Dominion Energy

Pre-Submittal Meeting License Amendment Request for Moderator Temperature Coefficient Analytical Verification

REACTIVITY CONTROL SYSTEMS
SURVEILLANCE REQUIREMENTS

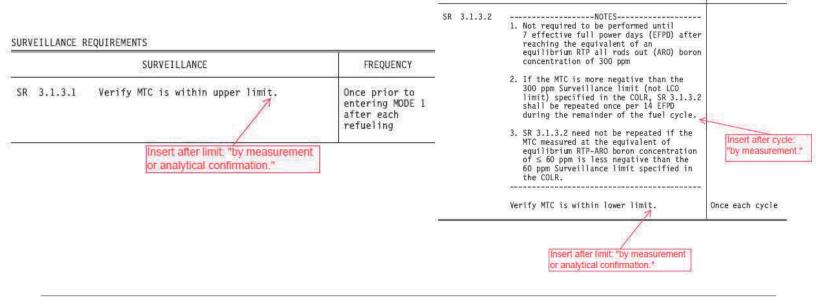
- For MPS3 and VCS, change TS 4.1.1.3.a/b to read: "The MTC shall be verified by measurement or analytical confirmation..."
- Additional requirement for TS 4.1.1.3.b that if the 300 ppm surveillance is not met, measurement will be performed.

Insert after shall be: "verified by measurement or analytical confirmation"

Insert after shall be: "verified by measurement"
